PHOTOVOLTAIC SYSTEM SCHEMATIC	
Scale: 1:50	Drawn by: [Redacted]
Checked by: [Redacted]	Approved by: [Redacted]
Project Number: NEC00062	Drawing Number: HYD5-E-DRW-0020
Revision: 4	Issue Date: [Redacted]

CONTROLLED	CLIENT
DRAWN	DRAWING TITLE
CHECKED	SOLAR INVERTER INTERFACE CONTROL BOARD GENERAL ARRANGEMENT
DATE	25.11.16
SCALE	PROJECT
NONE

GPD Settings (Woodward EasyProtect) - Darling Harbour Live

MSB-1
Basement

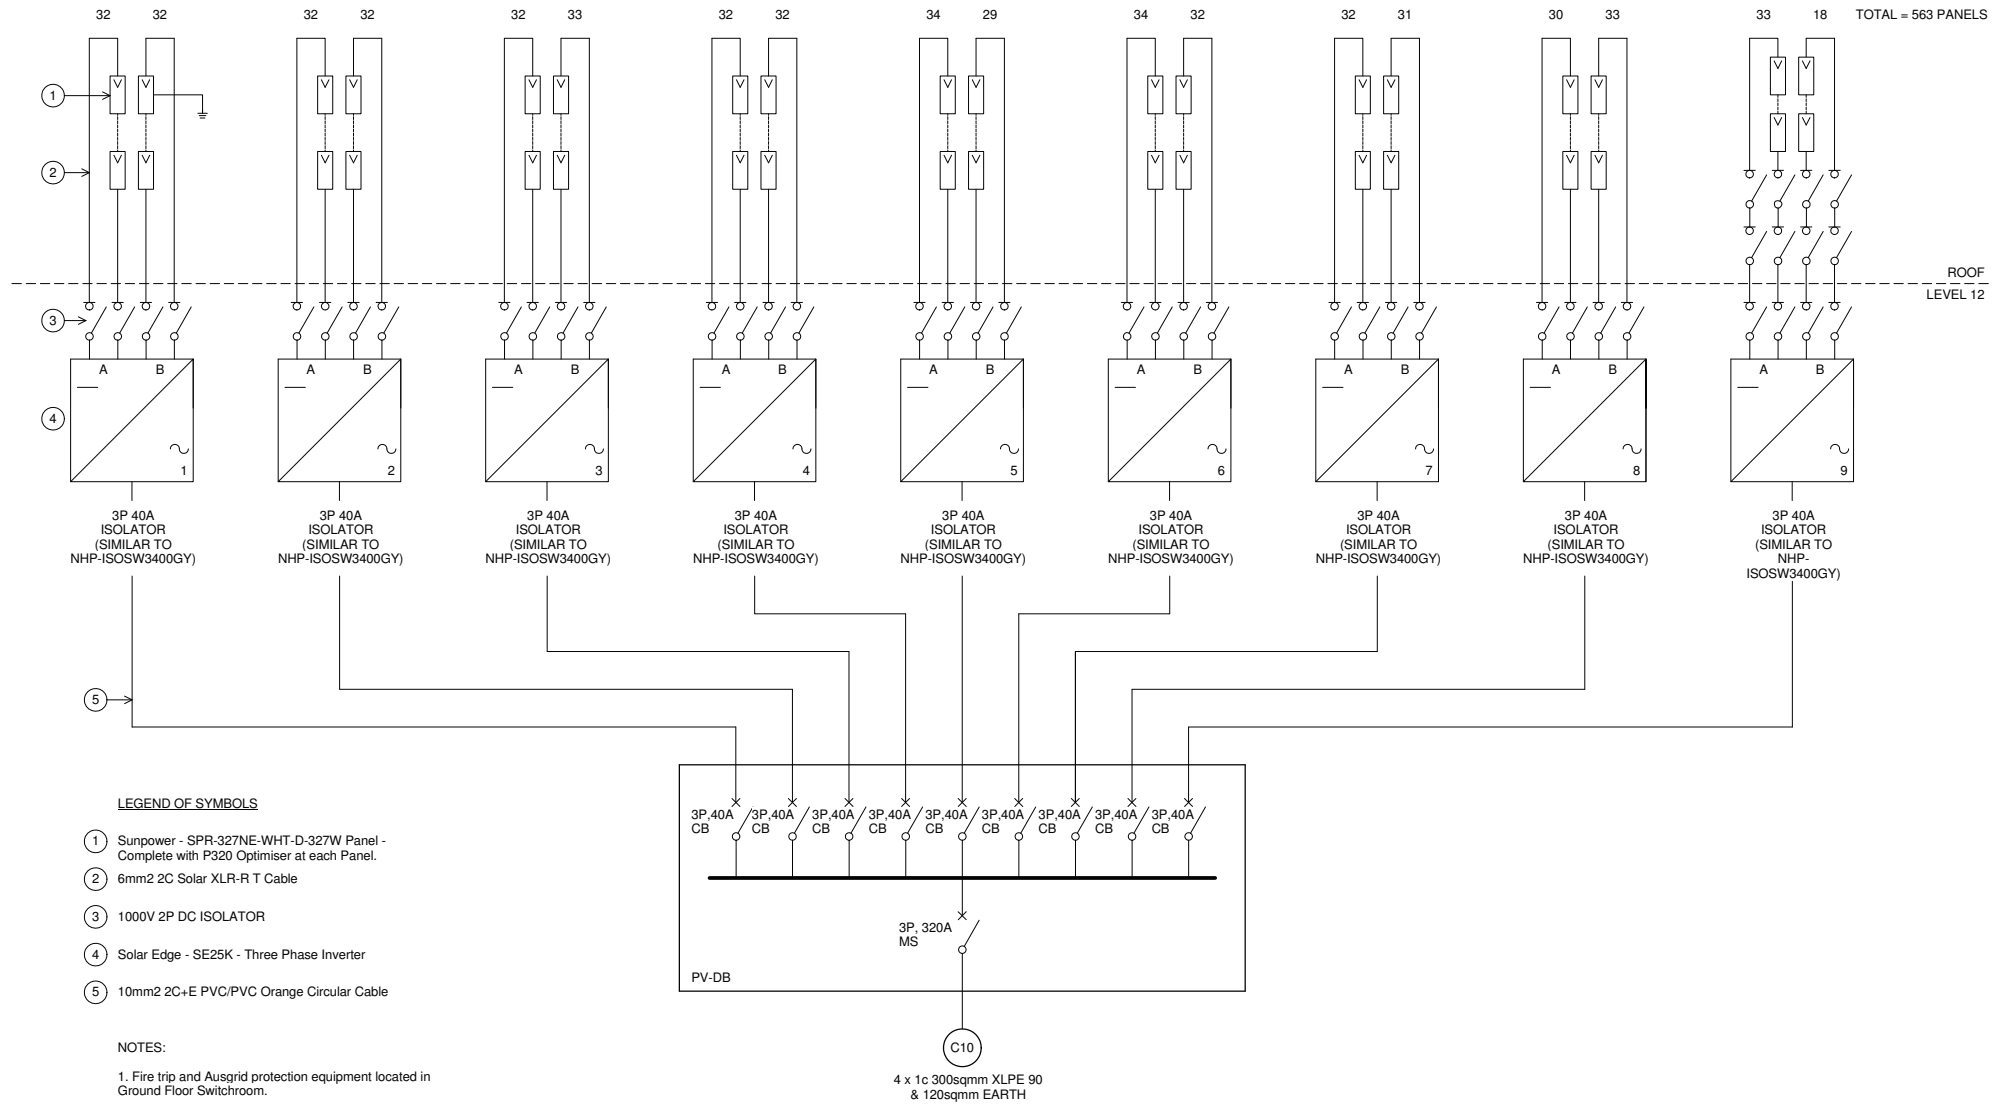
300 3Ph MCCB
400
in MSB-1. Terminal numbers to be updated. Undervoltage release to be added.

notes:
1. Contractor to add terminal blocks at required location
2. MCCB to be fitted with undervoltage release
3. Equipment terminal numbers to be confirmed by contractor
4. Contractor is responsible for equipment rating, wiring sizing to relevant AS/NZS standards
